MISSISSIPPI POWER & LIGHT COMPANY

July 22, 1985

SUBJECT: Grand Gulf Nuclear Station
Unit 1
Docket No. 50-416
License No. NPF-29
File: 0260/L-860.0
Revised FSAR Section 13.2, GGNS
Staff Training Program
AECM-85/0217

FIGURE 9B-1

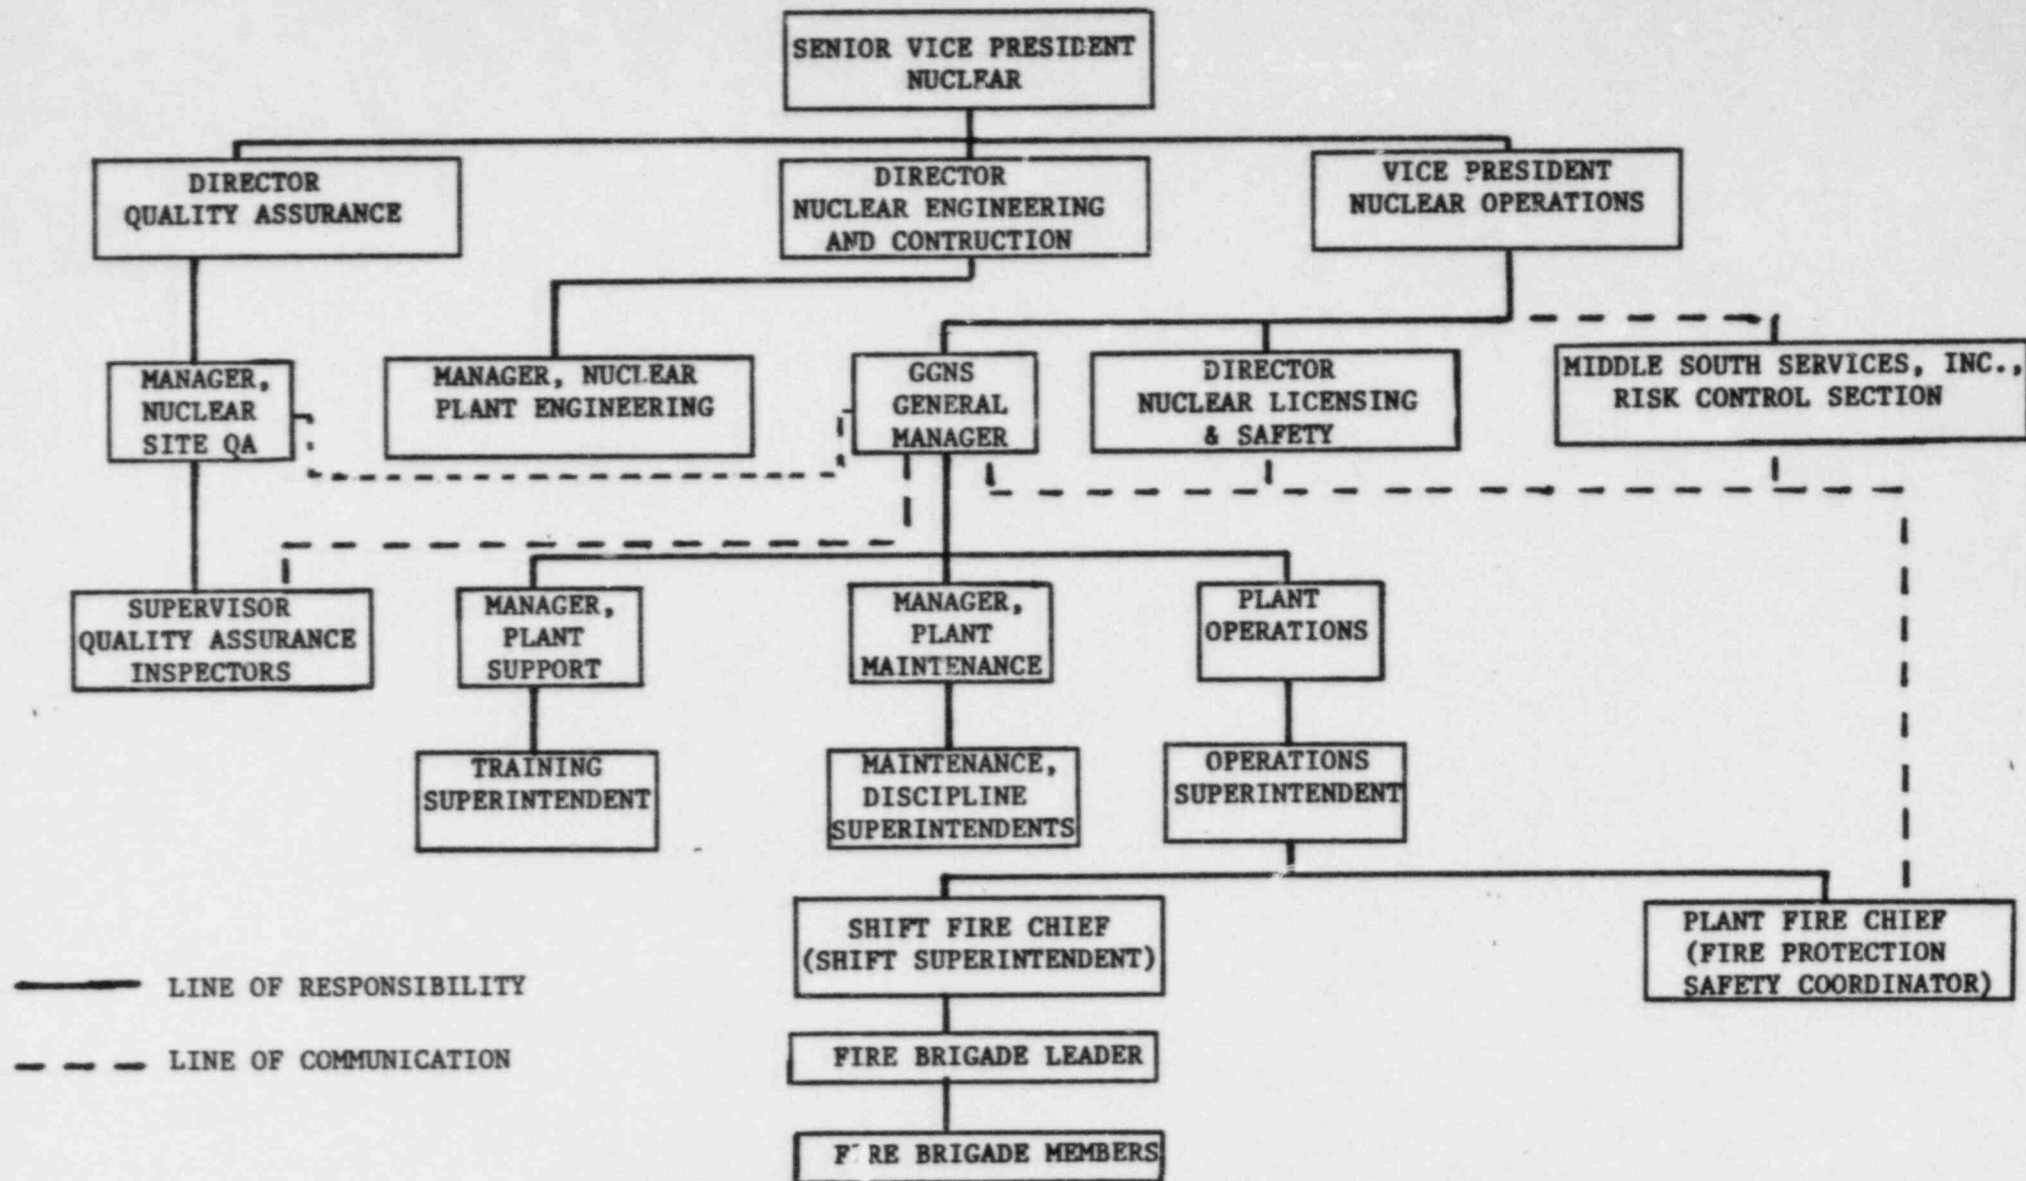
12. Figure 9B-1
